**APPLICATION OVERVIEW**  
**SKETCH PLAN REVIEW**  
**ARTICLE 7, SECTION 7.3**

<b>DRB DOCKET #:</b>	DRB-19-10
<b>APPLICANT(S):</b>	Marty Baslow
<b>CONSULTANT(S):</b>	Donald L. Hamlin Consulting Engineers, Inc.
<b>PROPERTY ADDRESS (PARCEL ID CODE):</b>	37 Warner Creek (WC037)
<b>ZONING DISTRICT(S):</b>	Rural Residential and Soil & Water Conservation
<b>INITIAL FILING DATE:</b>	Tuesday, July 23, 2019
<b>APPLICATION COMPLETION DATE:</b>	Tuesday, July 23, 2019
<b>SCHEDULED HEARING DATE:</b>	Monday, September 16, 2019

MARTY BASLOW  
SKETCH PLAN REVIEW  
Docket #: DRB-19-10

**Project Proposal:** Sketch Plan Review of Marty Baslow for a proposed 2-Lot Subdivision of property located at the aforementioned address.

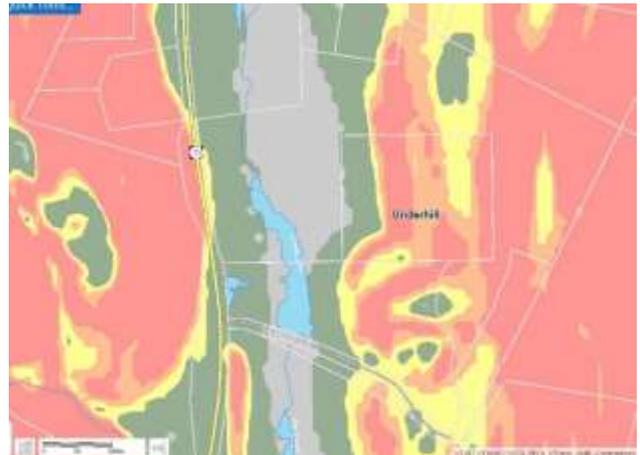
- Areas of steep slopes (15-25%) are present on the existing lot (see directly to the right).
  - Based on the subdivision’s configuration, Parcel A seemingly has no area where development is feasible due to steep and very steep slopes.
  - The one area that is under 15% slope is close to the property’s boundary and would likely require a dimensional waiver or variance.

DATE	REVISION	BY
CLIENT <b>MARTY BASLOW</b> 65 COLONEL PAGE ROAD ESSEX JUNCTION, VT 05452		
PROJECT TITLE <b>BASLOW SUBDIVISION</b>		
DRAWING TITLE <b>SKETCH PLAN</b>		
Drawn	---	Scale 1" = 100'
Design	---	Job 19-245
Team	BPD	File
Checked	RFH	Drawing
Date	6/18/2019	<b>SK-1</b>

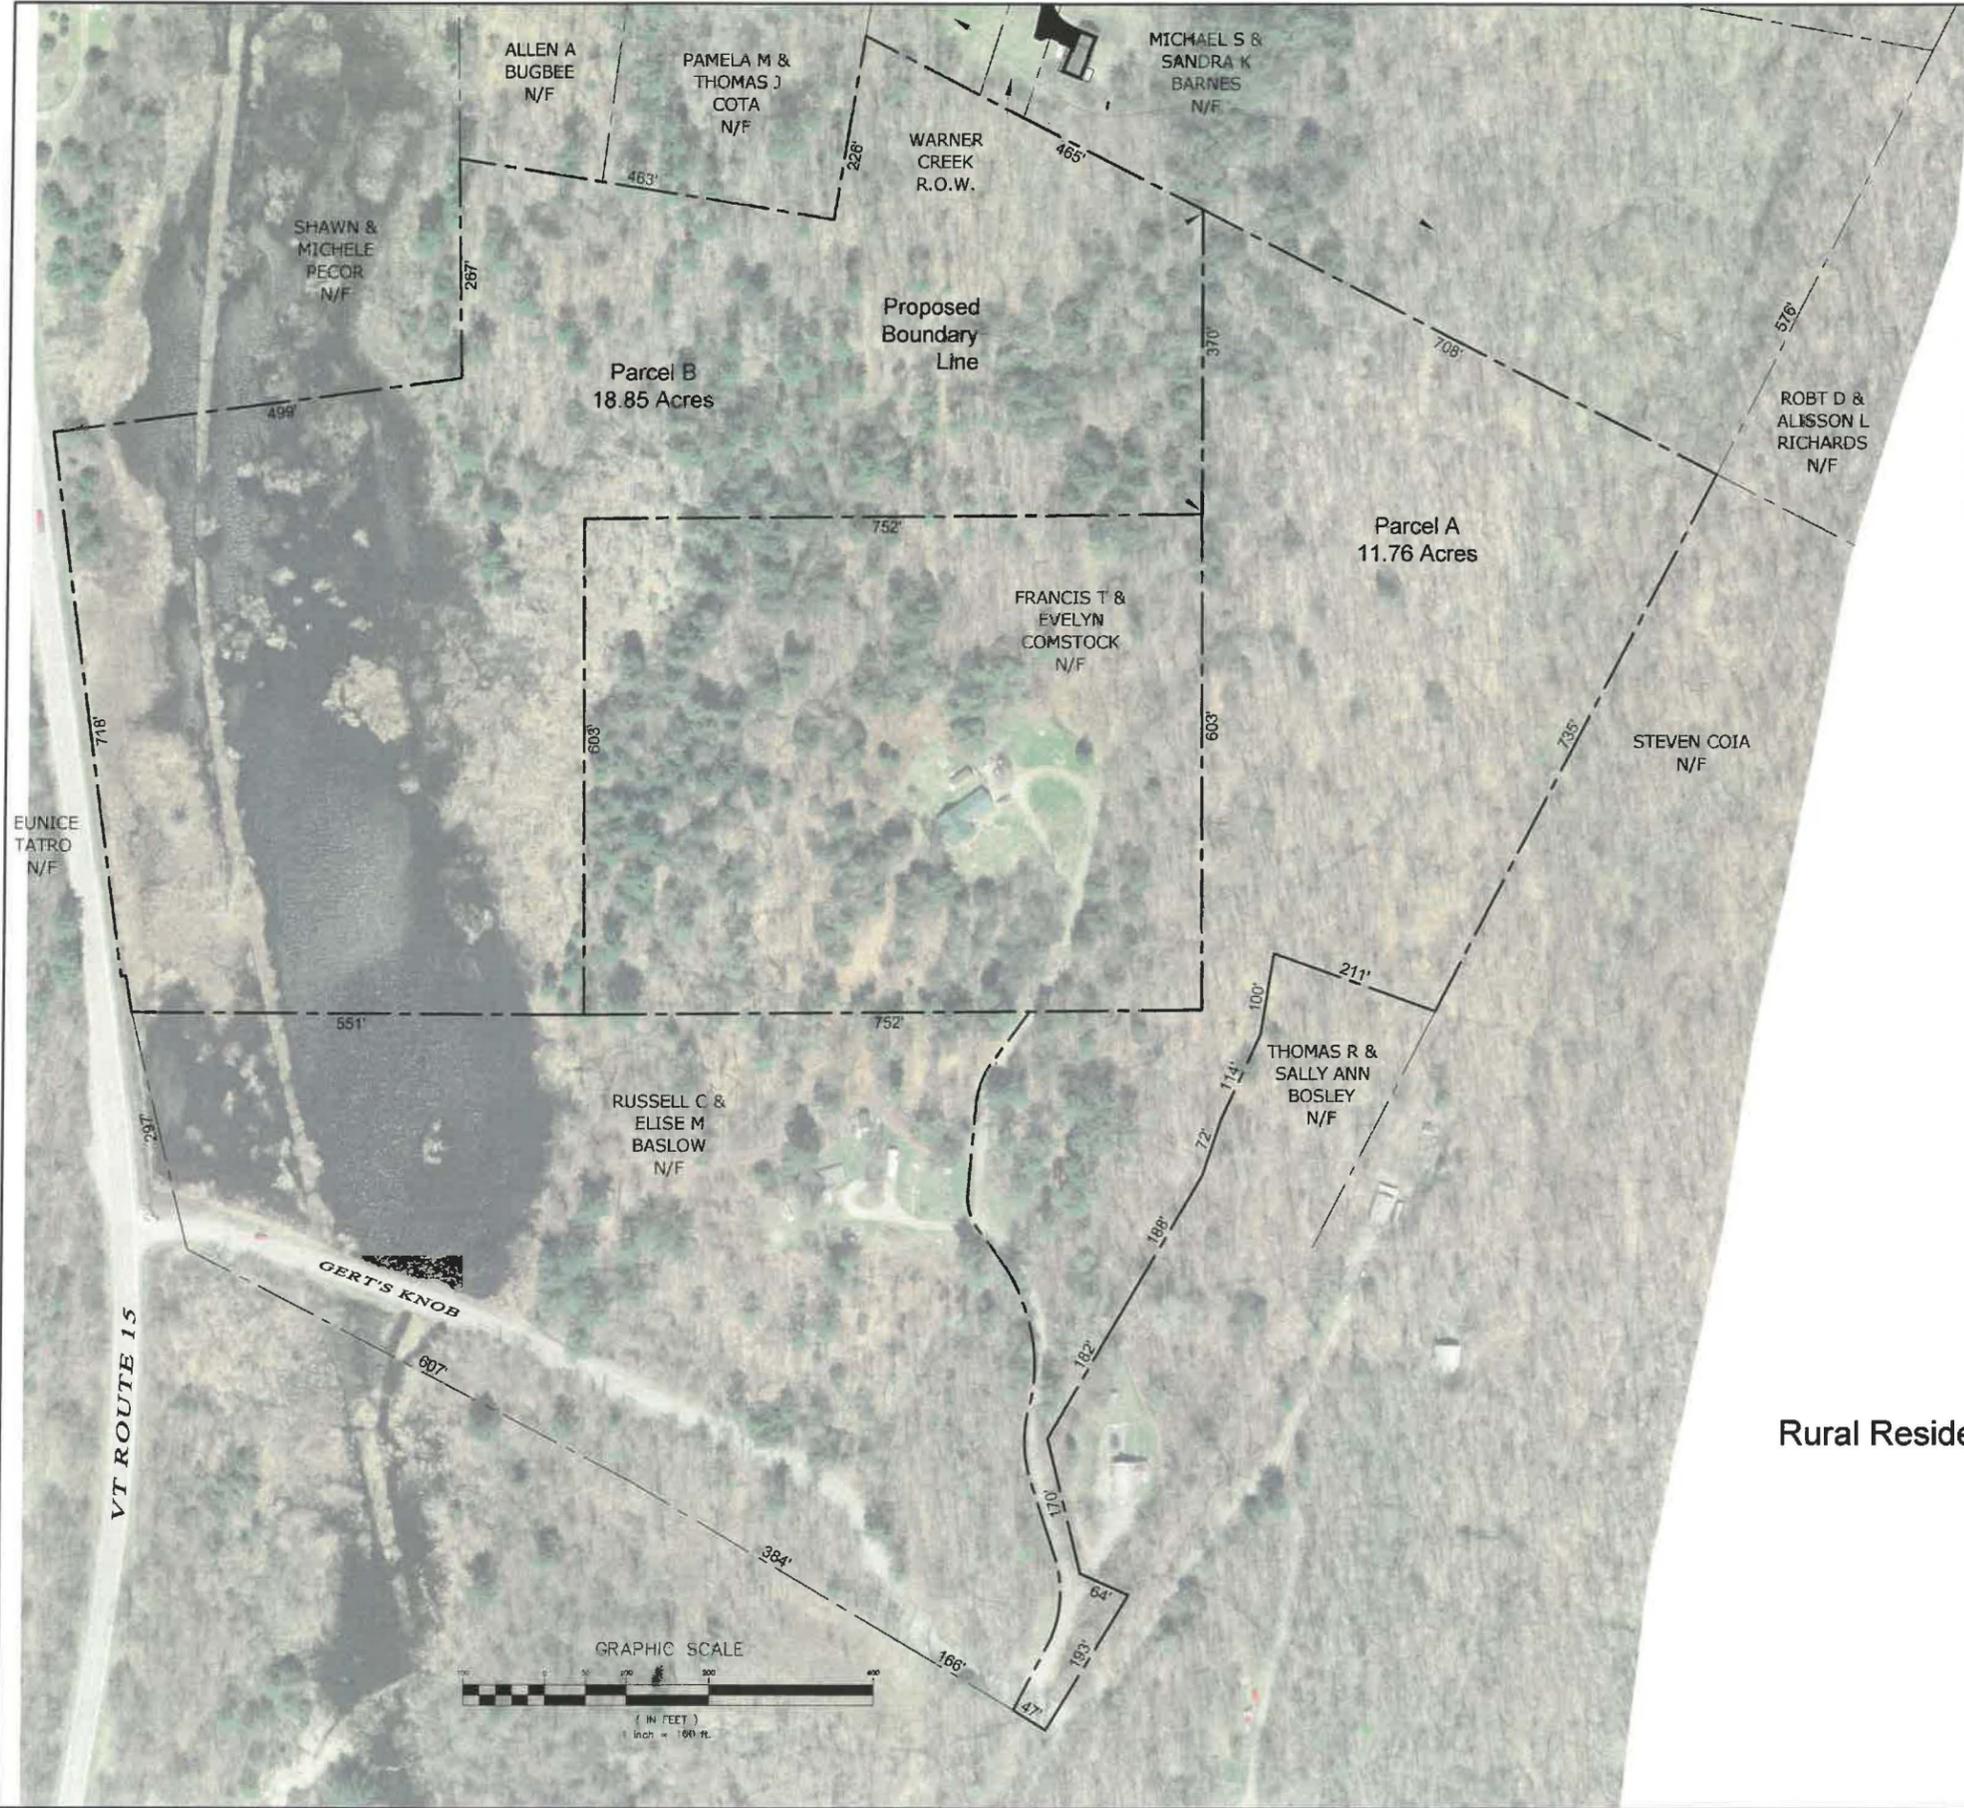
1. **TABLE 2.7 – SOIL & WATER CONSERVATION:** Parcel A could potentially contain an area of the Soil & Water Conservation zoning district, and if so, the ±11.76 acre lot will be nonconforming, as the required acreage is 15.0 Acres.

2. **SECTION 3.18 – STEEP SLOPES:** Based on the subdivision’s configuration, Parcel A seemingly has no area where development is feasible due to steep and very steep slopes.

5. **SECTION 8.2.F – LAYOUT:**
    - a. The proposed Parcel A could potentially be prohibitive regarding subsequent development due to the steep topography (§ 8.2.F.1).

- b. The proposed Parcel A could potentially be undersized should the lot contain an area of the Soil & Water Conservation District (§ 8.2.F.3 & §8.2.F.4).

6. **SECTION 8.2.G – BUILDING ENVELOPES:** The Applicant has not identified a building envelope.
  7. **SECTION 8.8 – LEGAL REQUIREMENTS:** The Board should determine what draft legal documents they would like to see during the preliminary & final subdivision review hearings; most likely information relating to a draft Road Maintenance Agreement.
-
